**RE: Las Lomas Plaza – Phase 1
Grading Plan
Stamp Date: 8/22/17
Hydrology File: H10D031**

Based upon the information provided in your submittal received 8/24/2017, the Grading Plan **is not** approved for Building Permit. The following comments need to be addressed for approval of the above referenced project:

LAS LOMITAS PLAZA
 GRADING & DRAINAGE PLAN

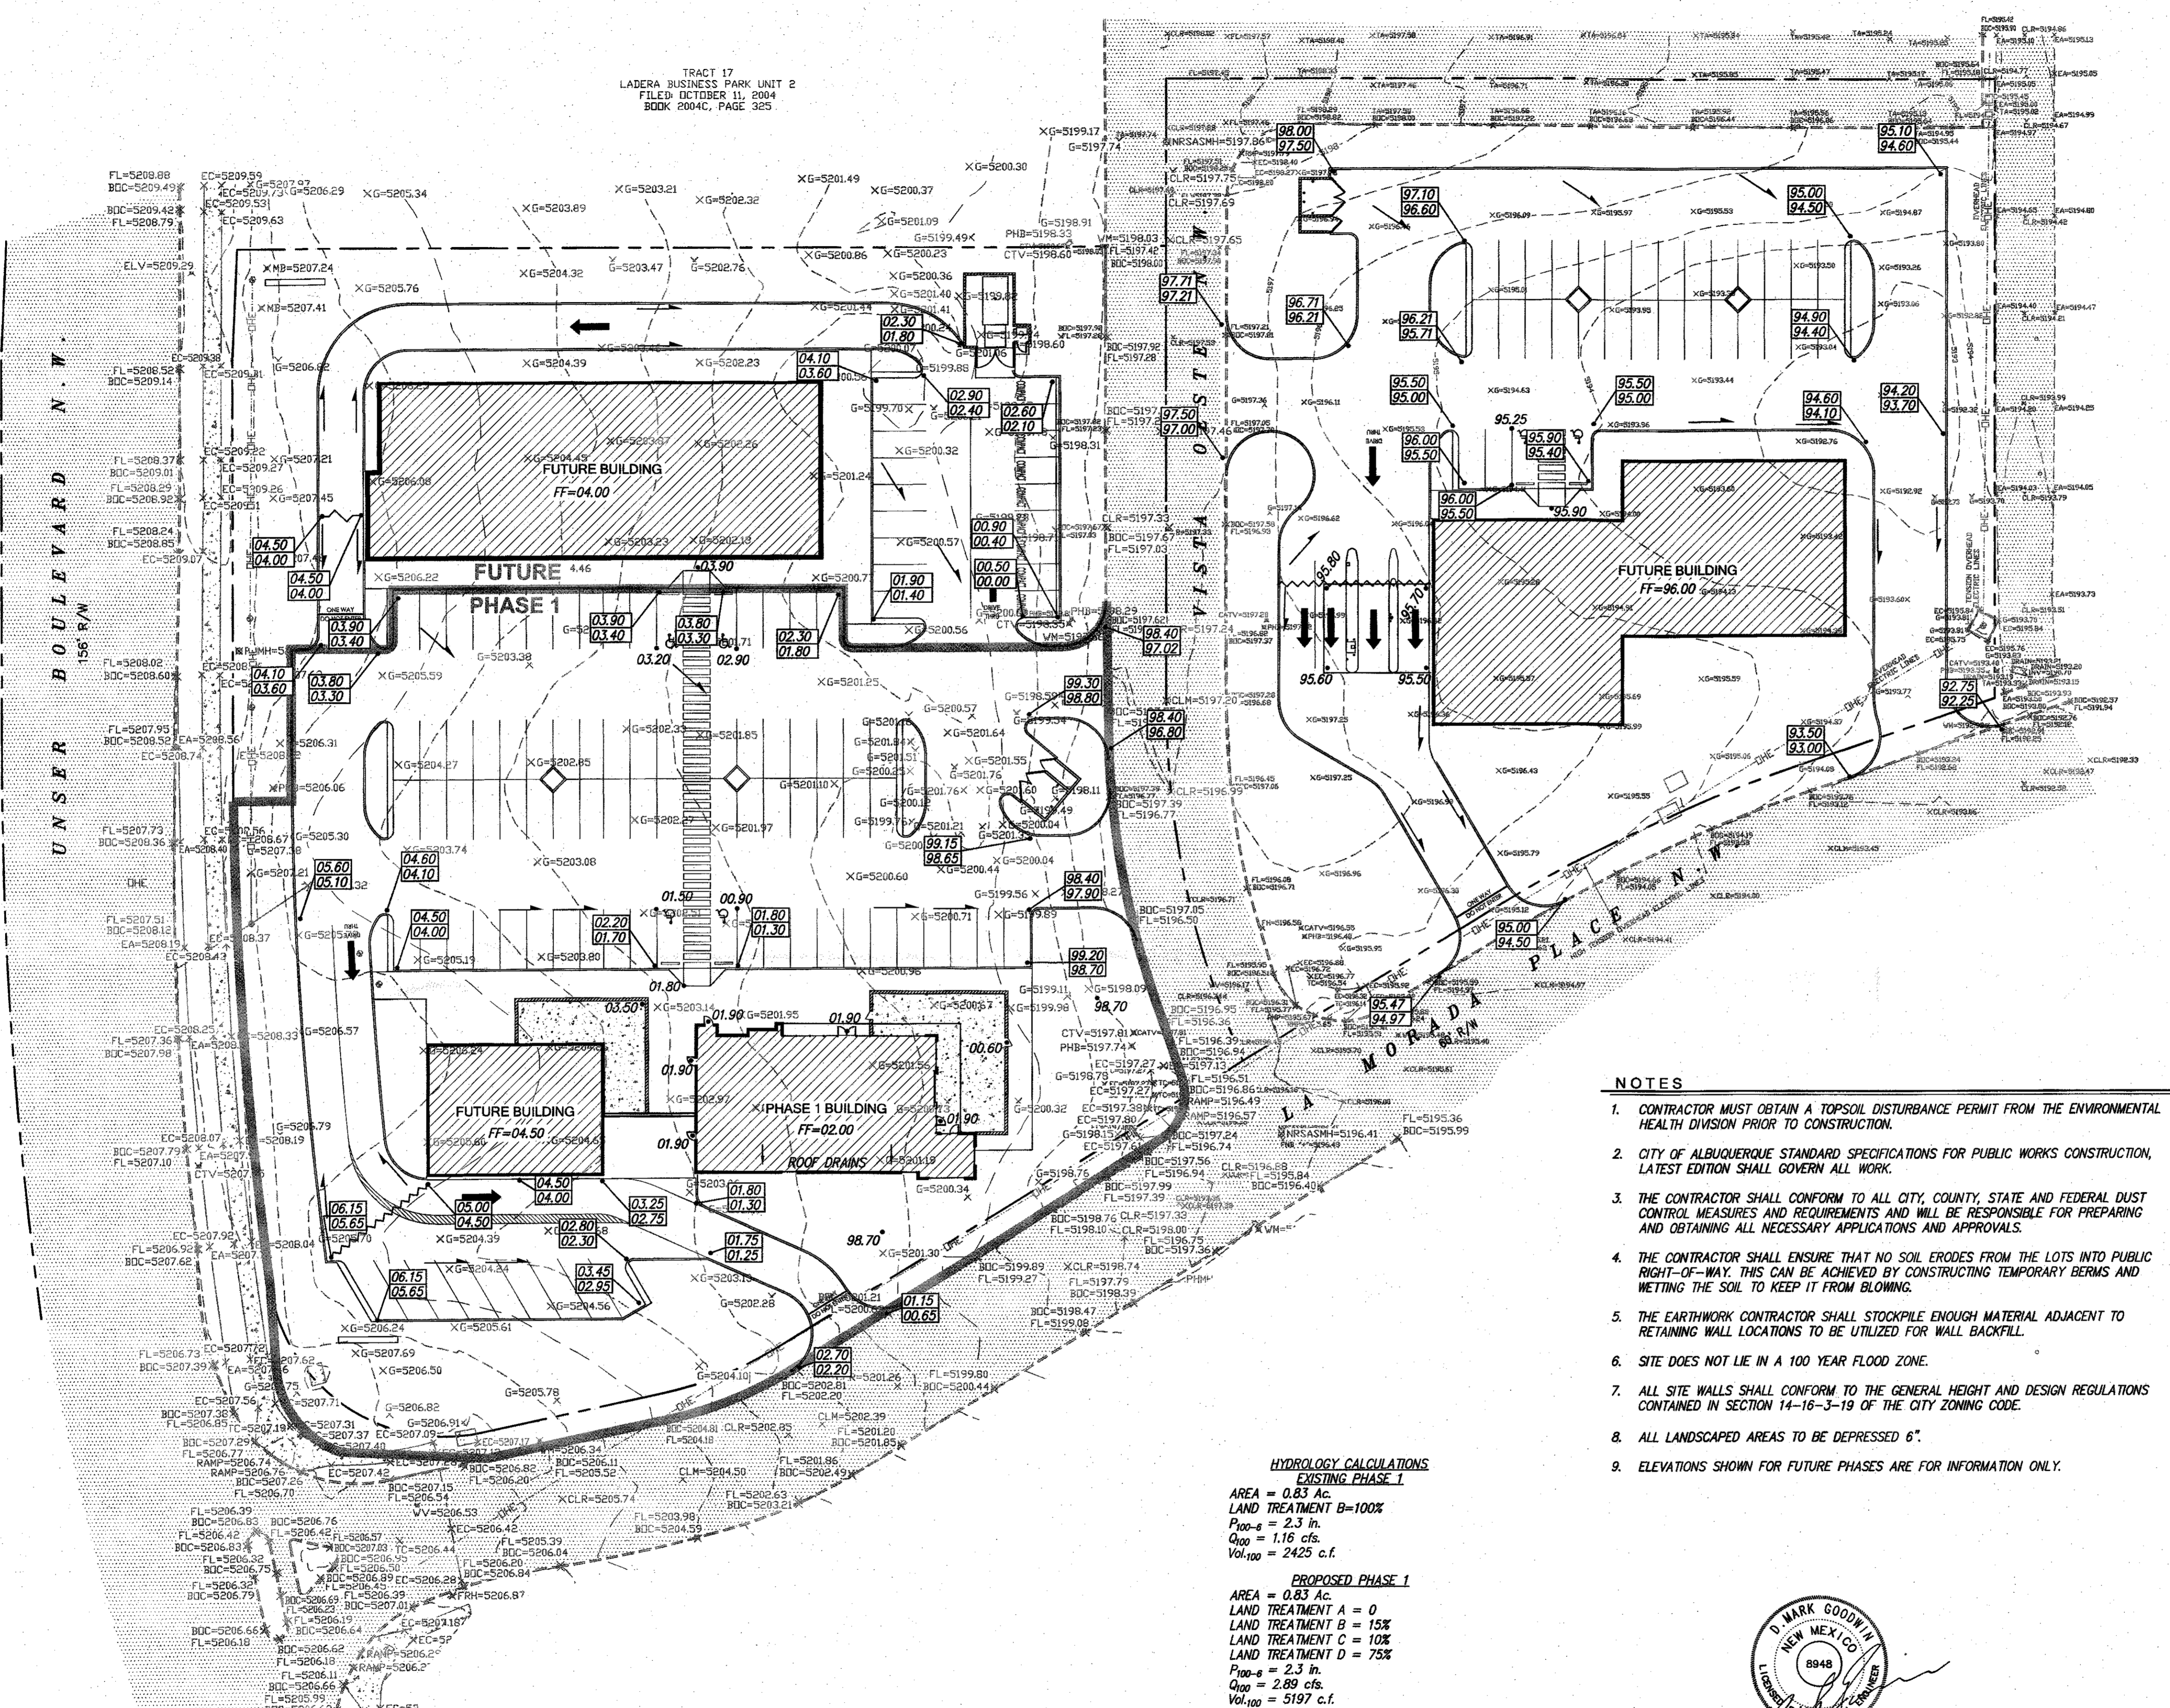
1. As stated this property is not in the 100 year flood zone. However, please provide the flood plain note with effective date.
2. Phase 1 is part of Tract 15 (1.24 ac) and Tract 16 (1.20 ac). The area noted for Phase 1 of 0.83 ac appears to be wrong and the grading plan for Phase 1 shows more than 1 acre of disturbance is being proposed. Therefore, an Erosion and Sediment Control Plan is required and has to be submitted to the storm water quality engineer (Curtis Cherne, PE, ccherne@cabq.gov). Hydrology's approval for Grading or Building Permit will not be given until the submittal of the ESC Plan.

3. For the first flush basins (the depressed landscape areas), please provide the volumes of each and indicate them on the Grading plan.
4. Please show some curb cuts so that the runoff can drain into the first flush basins and a curb cut so that the pond can drain. Also please show the drainage going into these basins and please provide weir calculations for the curb cuts.

5. Please show Cross Lot Drainage Easement agreement on the Grading & Drainage Plan specifying the beneficiary and maintenance agreement. If There is not agreement, a Cross Lot Drainage Easement Agreement is needed.

6. Under Legal Description. Since this is just for Phase, please change the Tracts to just 15 & 16.
7. Please add the words, "Phase 1" to the project title.
8. Under Legend. Please add the two proposed Boxes showing the proposed TC & FL.
9. In general, please move the floating leaders for each of the TC & FL boxes to the correct curb location. There are multiple floating leaders.
10. Please add TC & FL information on the two islands in the Phase 1 parking area.
